ALTERATION TO A HISTORIC PROPERTY STAFF REPORT

Site / District(s) 50 Bow Street (Unit 12) / LHD & NR
Case: HPC 2013.079

Date of Application: 10/17/2013
Legal Notice: *Replace Windows.*

South facing windows, photos September 2013.

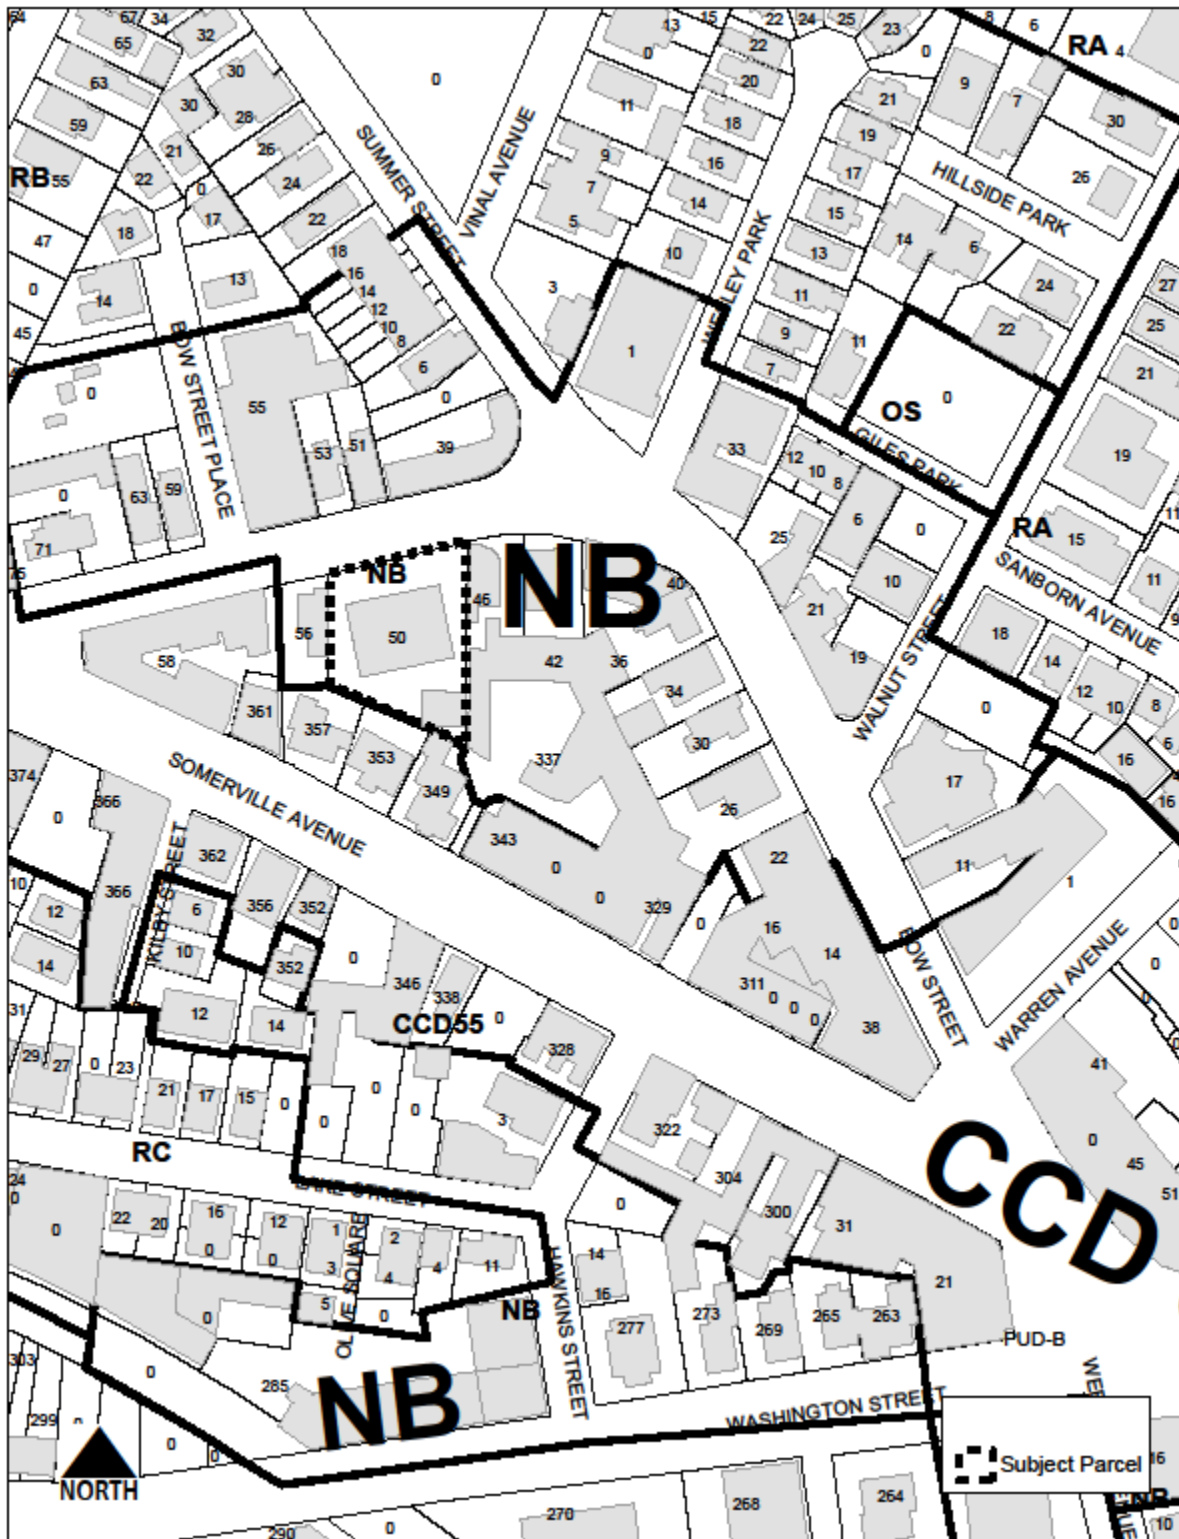
- *What is the visibility of the proposal?*
One of the two rear façade windows of Unit 12 is visible from Somerville Avenue, while the two windows located on the right side façade are visible from Bow Street. The proposed replacement windows meet the qualifications listed above as they are not located on the main façade, the sash and glass panes match the existing window measurements, although the muntin profiles would be necessary to alter manually, and the proposed replacement windows have already been approved by the HPC for Unit 4 and Unit 6. .

- *What are the Existing Conditions of the building / parcel?*
The HPC should recognize the deteriorating nature of the original replacement windows for this entire building. While this building was rehabilitated more recently, residents unknowingly inherited flaws regarding poor installation of the replicated windows that were either created at the time of the rehab or were already present and not fixed at that time. Weather stripping and/or caulking around windows within a historic building is often necessary and always recommended, and, although this could help, the windows are greatly warped.

Although the replacement windows proposed contain a low-emittance coating, which is not preferred for a historically designated building and do not meet the general *HPC Guidelines*, the precedent has been set for Applicants to request these window specifications for replacement as this will allow the building to become consistent over time as replacement windows become necessary for other units.

The proposed windows for Unit 12 do not meet *Design Guidelines*. However, two applications for the proposed windows have already been approved by the HPC and installed, and the location of the proposed replacement windows would have a minimum adverse effect on the historic character of Bow Street. Staff recommends granting a Certificate of Appropriateness to replace both windows on the right side façade and one on the rear at 50 Bow Street, Unit 12, while a Certificate of Non-Applicability will be issued to replace the window on the rear façade that is not visible from a public way. This Certificate is conditional upon the replacement windows matching those that have already been replaced on the building in that they have the same low-emittance coating, muntin profile, and light division. Staff also recommends the HPC to authorize Staff review regarding future requests for these window specifications for this building (see authorization statement).

THIRD FLOOR PLAN

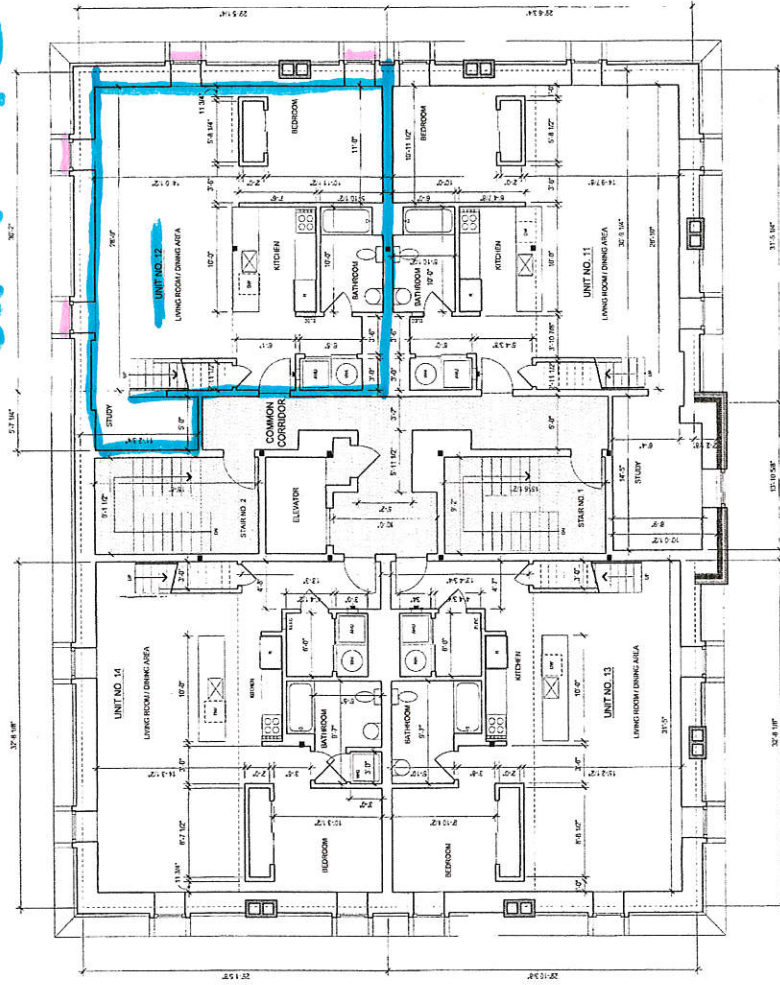
The Applicant proposes to replace four windows in Unit 12, located in the right rear corner on the third floor. Two windows are located on the rear façade and only one is visible from a public way (Somerville Avenue) and two windows are located on the right side façade and are visible from Bow Street. All four windows would be replaced within the existing opening with Marvin Ultimate Magnum double-hung, insulated, wood windows with two-over-two lights and two panes of glass with a spacer between the panes. This specific brand and type of insulated window has been previously approved for this building as the JB Sash replacement windows have not proven sufficient for this building. The original window casing will be reinstalled and any materials displaced as a result of removing the casing would be replaced in-kind.
